## **EXTINGUISH THE TORCH MEETING SESSION ONE**

Project: Resurfacing & Safety Upgrades of Turnpike Mainline (SR 91)

## Summary Report

## Lessons Learned

### 1) Metal Traffic Railing (Thrie Beam Retrofit) – Missing pay items & MOT

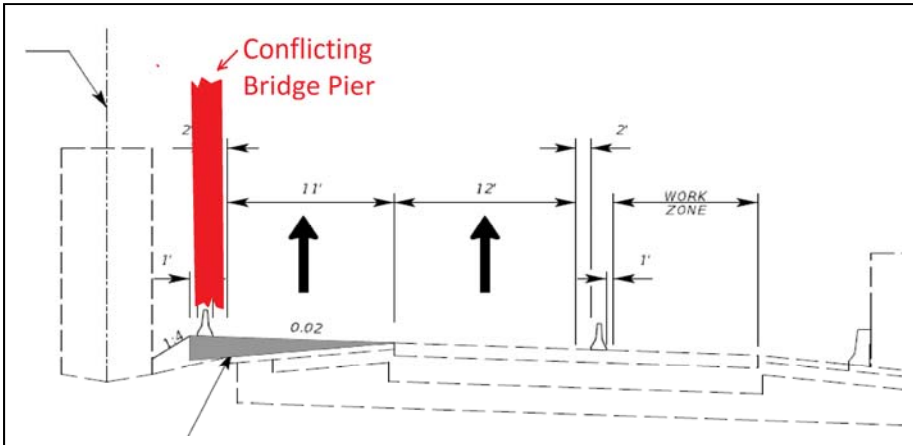
Plan details and pay items were not included in the contract, for planned thrie-beam upgrades to bridges crossing over the Turnpike. Several challenges would result if this work had been pursued, as several work components were not included in the contract (such as traffic coordination with Osceola County, and additional costs not in the original contract).

Quantities not included in the contract for the thrie-beam installation: Barrier Wall Temporary, F&I, Type K, Temporary Crash Cushion, Redirective Option (8 installations), MOT associated with thrie-beam operation, striping plan, advance warning, and thrie Beam transition from bridges. The estimated cost for these omitted items was approximately \$150,000.

Also, note that a 4' work area restricts the Contractor's equipment access.

The thrie-beam retrofit work was deleted from this project. A future widening project is planned at these four bridge locations.

Recommend an evaluation of bridge sites during design, to fully understand & define the MOT needs.

EOR to provide details on connection of thrie-beam to existing guardrail.

## 2) Conflict between bridge pier & temp. barrier wall during diversion

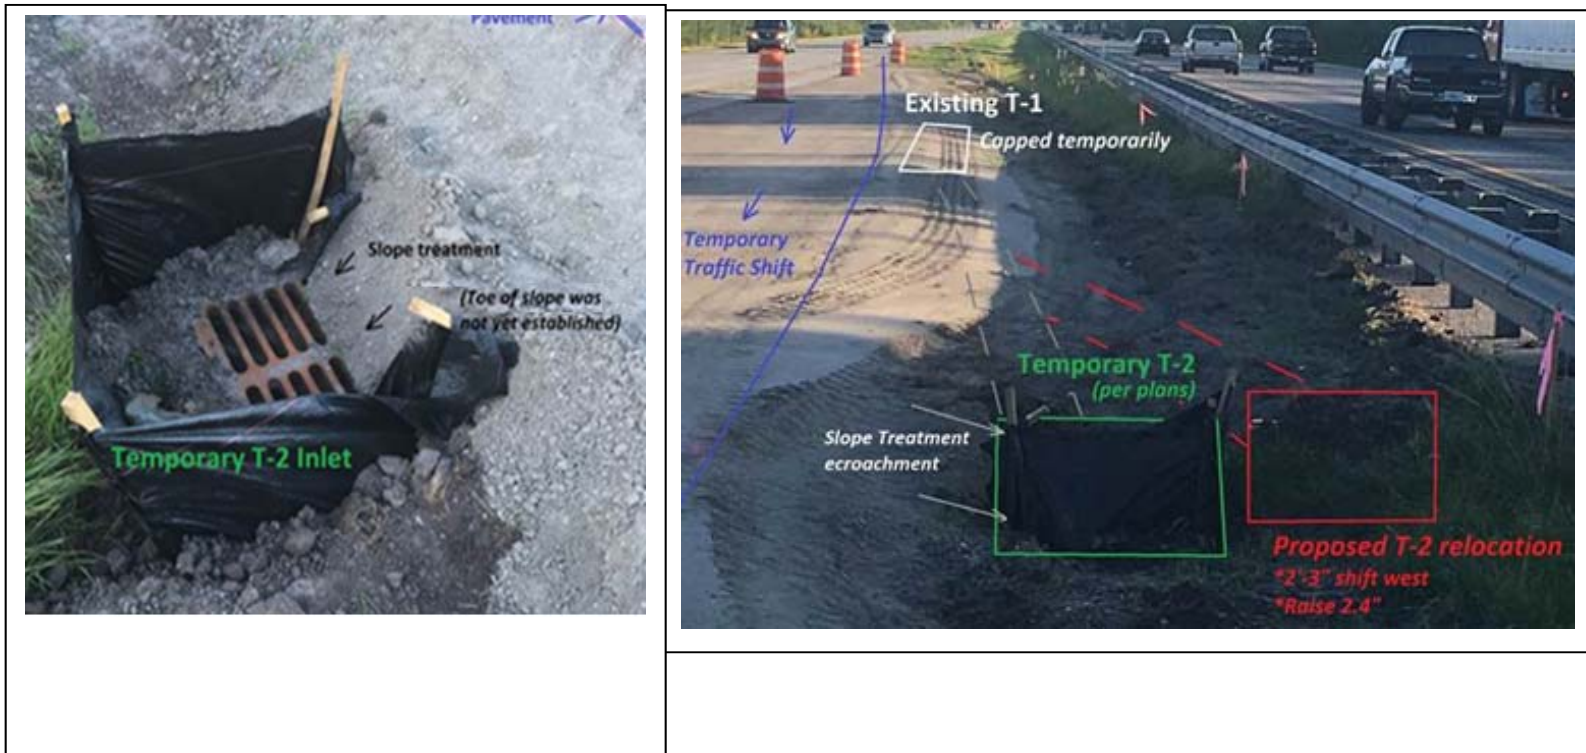
The Neptune Road bridge pier was located within the limits of a temporary diversion, and would not allow the required 11' & 12" lane widths. This temporary diversion was needed to deep mill the northbound lanes to repair full depth cracking.

Shortened the traffic diversion length to avoid the bridge pier. The remaining diversion length was paved with a continuous milling & paving operation (Sunday afternoon through Monday morning), without the use of a barrier wall.

Design team to account for any conflicts when designing traffic diversions. In this case, the presence of a bridge pier had not been taken into account.

4) Ramps typical sections didn't show begin/end stations for milling & resurfacing

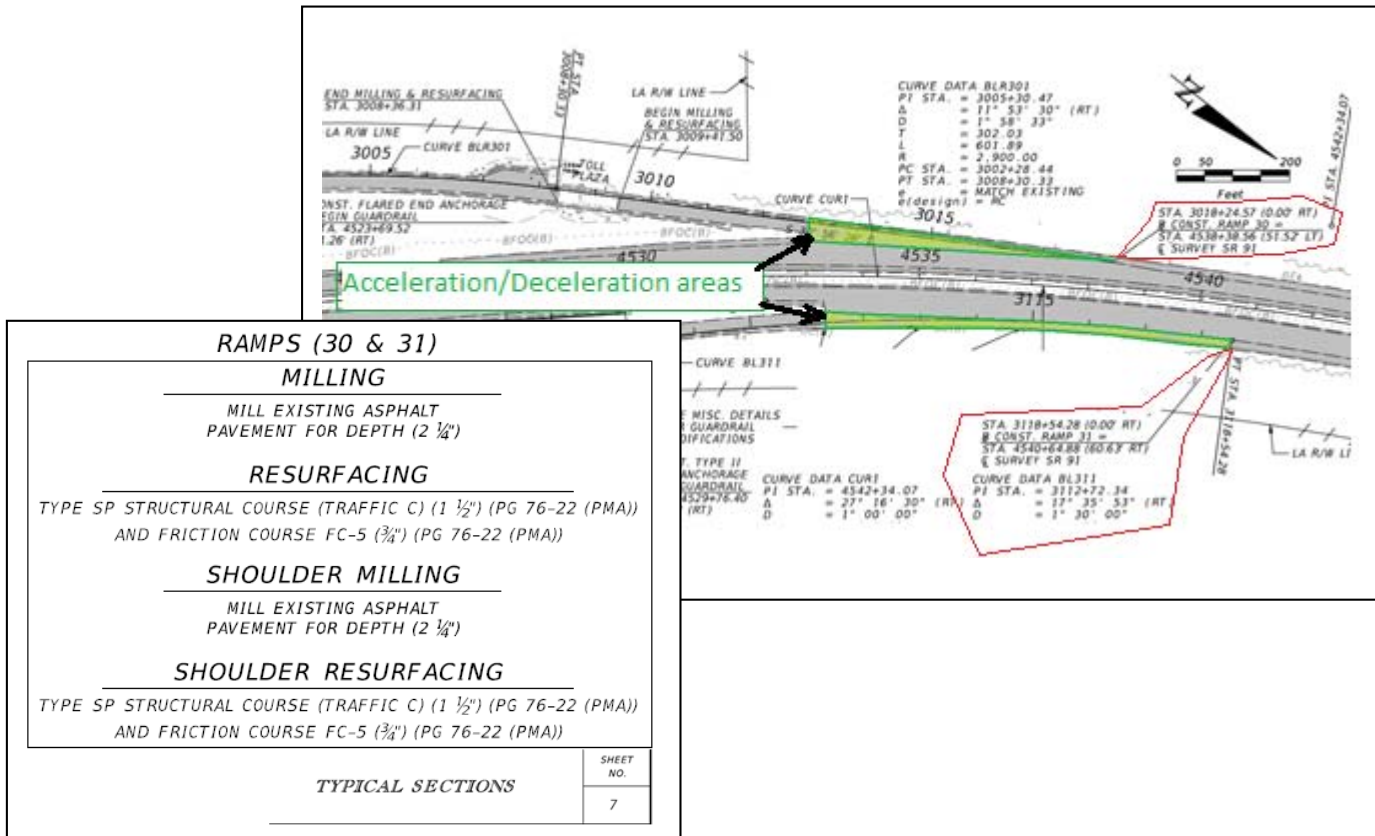
Typical sections do not show stations, which leads to confusion about resurfacing scope for ramp accel/decel lanes.

Clarification was obtained to establish the ramp limits. This involved coordination with the EOR, Bituminous Engineer and Contractor.

Depict ramp limits starting & stopping at the gore area.

This could be done by including limits on typical sections or a legend on plan sheets.

5) Bridge Joint Replacement Quantity Errors

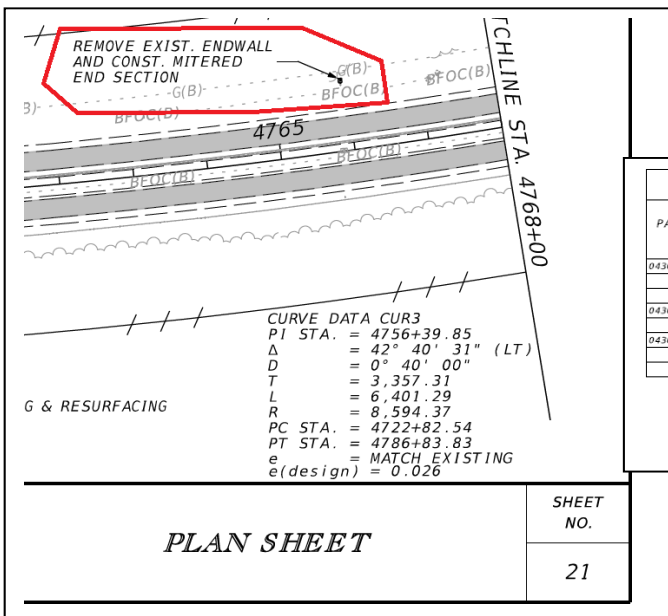
The plan quantities were not correct

- Two pay items are required for this work, per Basis of Estimates & Specification:
  - Bridge deck expansion joint pay item – successfully included in this contract
  - Polymer nosing pay item (# 458-2) – was OMITTED from this contract
  - Contractually, the Contractor was entitled to separate payment for the omitted pay item, but did not request it.
- Inaccurate quantities for bridge on SR 91, over St. Cloud Canal. Two separate bridge lengths should have been quantified, but only one was.

The Contractor fortunately didn't request separate payment for the omitted pay item. He bid his bridge joint expansion pay item to include the 2" of polymer material.

The pay item was overran at locations that weren't accurately quantified.

- Plans should include pay item 458-2 Polymer Nosing for Bridge Expansion Joints.
- Quantities need to be checked for bridge joints.

6) Headwall removal not included in summary of quantities

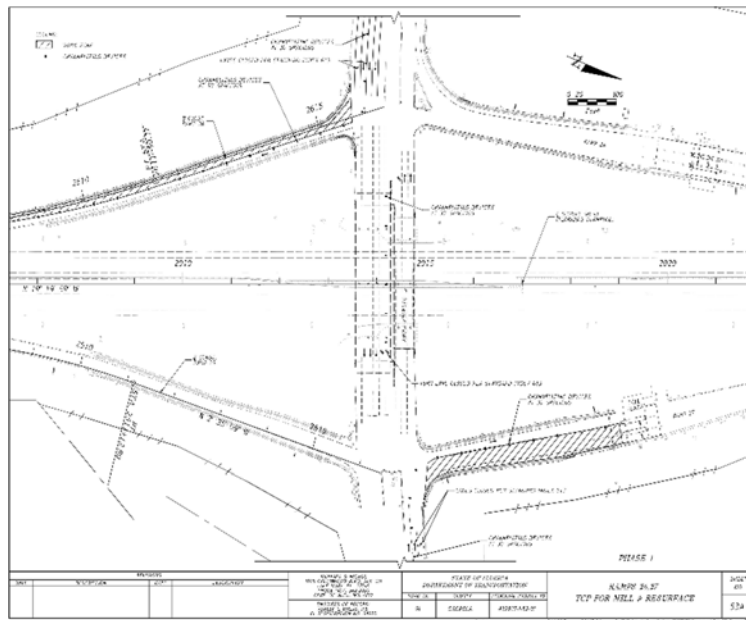
Plans removed an existing endwall & constructed a mitered end section. However, the summary of quantities didn't include pay items for the work. Only one other MES replacement was in the contract pay items, but was not the size needed. The note for this work was not seen until after all other drainage work was performed, and the Contractor had to re-mobilize to perform this work.

SUMMARY OF MISCELLANEOUS DRAINAGE ITEMS								
PAY ITEM NO.	PAY ITEM DESCRIPTION	LOCATION		SIDE	UNIT	QUANTITY		TOTAL
		STA.	TO STA.			P	F	P
0430 94 1	DESILTING PIPE, 0-24"	1433+75.00		RT	LF	24.0		142
		1437+50.00		LT/RT		118.0		
0430175124	PIPE CULVERT, OPTIONAL MATERIAL, ROUND, 24" S/CD	1437+50.00		LT	LF	6.0		6
0430982129	MITERED END SECTION, OPTIONAL ROUND, 24" CD	1437+50.00		RT	EA	1.0		1
	<b>Needed 18" MES @ Sta. 4766+00</b>

The Contractor was compensated by work order, to re-mobilize & perform the work. This included premium cost.

Summary of quantity sheets should accurately include all pay items for work.

7) MOT details at Osceola PKWY for ramp milling & resurfacing

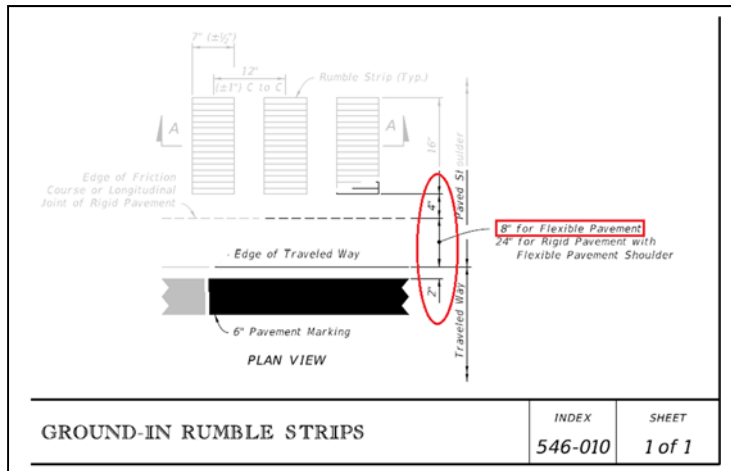
Contract did not provide MOT details for lane closures on Osceola Pkwy, which were required for the ramp milling & resurfacing. A dedicated right turn lane & one through lane on Osceola Pkwy required closure to prevent turning trucks from cutting across the construction zone.

Also, one of two left turn lanes, from Osceola Pkwy onto the Turnpike entrance ramp, required closure during paving operation. MOT details for this were not provided, and had to be produced during construction.

Lastly, lane closure coordination was not performed Osceola County, during design.

The EOR provided an MOT detail sheet, and the Contractor had to obtain a lane closure permit from the county (Osceola). Auto-turn analysis was required for MOT layout.

Contract plans should include MOT for paving near ramps terminations, and MOT coordination with adjacent counties should occur during design. Special attention is needed for multi-turn lanes & truck turning radii.

9) Conflicting Speed Limit Signage (Ramp 15)

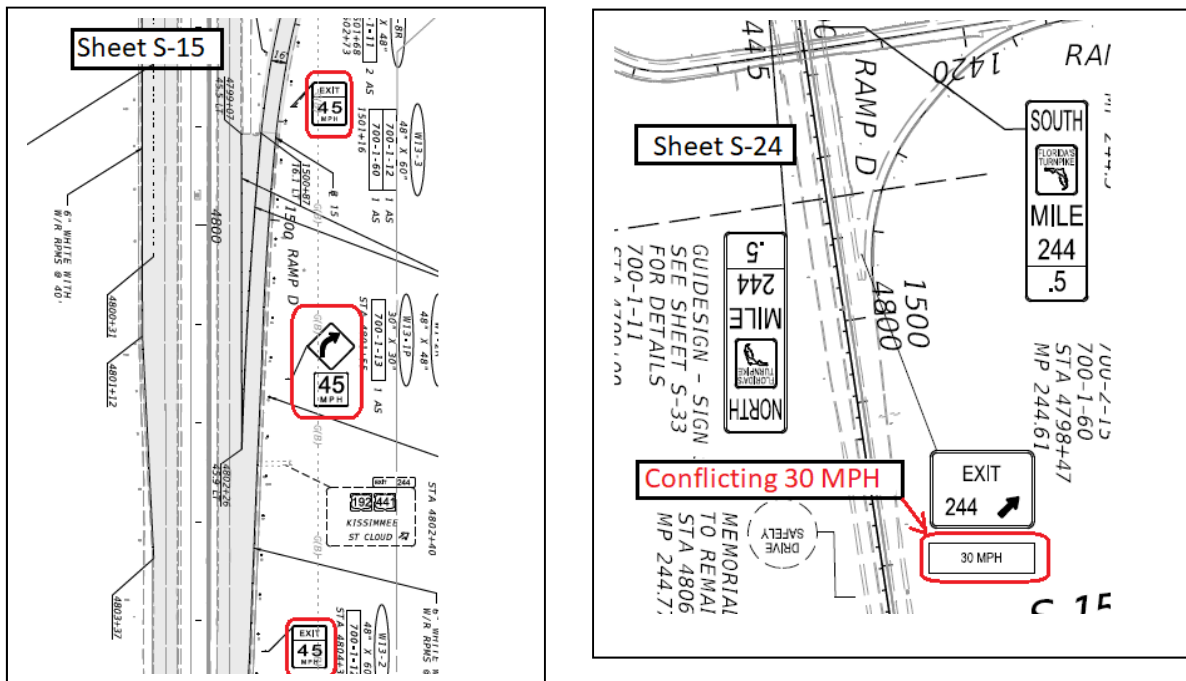
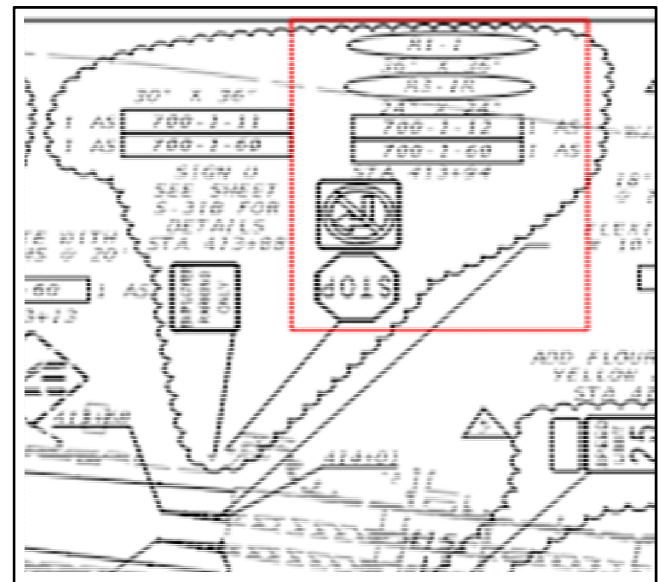
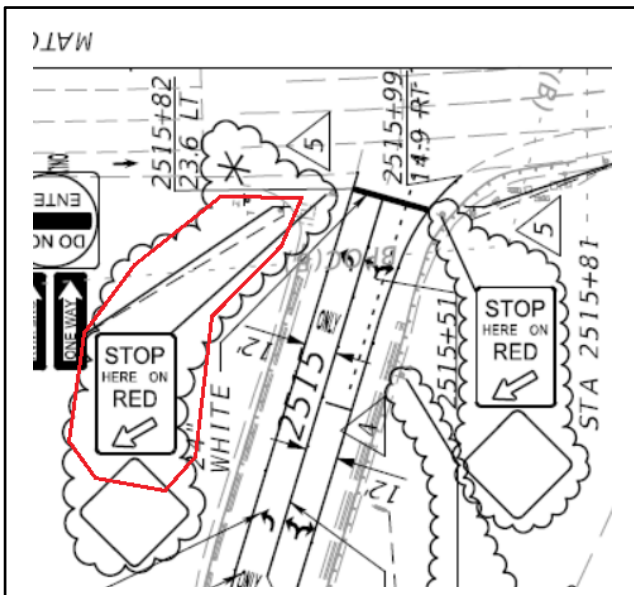
Conflicting speed signage was depicted at the same ramp location. One of the S&PM plan sheets called for installation of 45 mph advisory speed limit signs at three locations, while a different S&PM sheet called for '30 mph' on supplemental speed limit signage.

After review with Turnpike Traffic Operations & Production, the EOR revised the plan sheet to change the speed limit for two advisory signs to 30 mph, to coincide with the supplemental sign. The advisory sign closer to the mainline was also changed, from 45 mph to 40 mph.

If possible, all signs for a given location should be on the same plan sheet, rather than on multiple as shown above. Thoroughly review all sign sheets to ensure that there's no conflicting signs.

## 10) Sign arrows with wrong directions

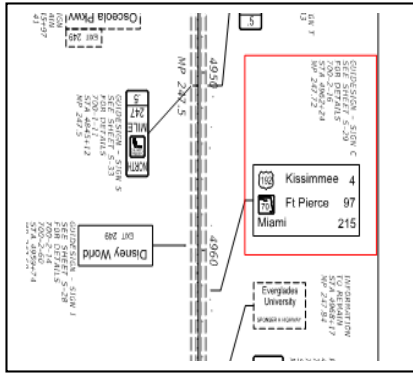
- “STOP HERE ON RED” sign; The arrow pointed wrong direction, toward shoulder instead of stop bar (NB Exit to Osceola Pkwy).
- Arrow under “STOP” sign; Arrow pointed in wrong direction (SB Exit to Osceola Pkwy)

The CEI & Contractor coordinated the correct arrow's installation.

Review plans & field conditions for correct direction of arrows.

## 11) Multi-post sign conflicting with FGT line

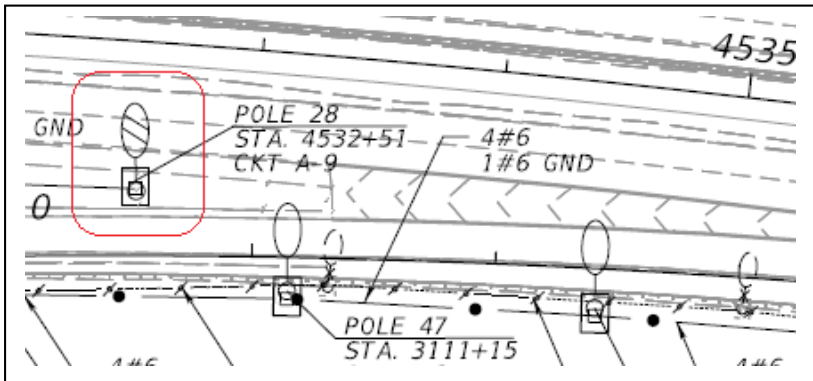
The S&PM plans called for installation of a new multi-post sign panel. The designed offset placed a sign post within 5 feet of an FGT line, which was not shown in the plans. The sign couldn't be shifted laterally, as it would conflict with either the clear zone or vegetation. It also couldn't be shifted longitudinally, since the FGT line ran continuously in this area.

After discussing with Production and EOR, the new multi-post sign remained the same location as existing sign at MP 248.01.

Cross reference existing utilities when designing signage plans, with special consideration for FGT.
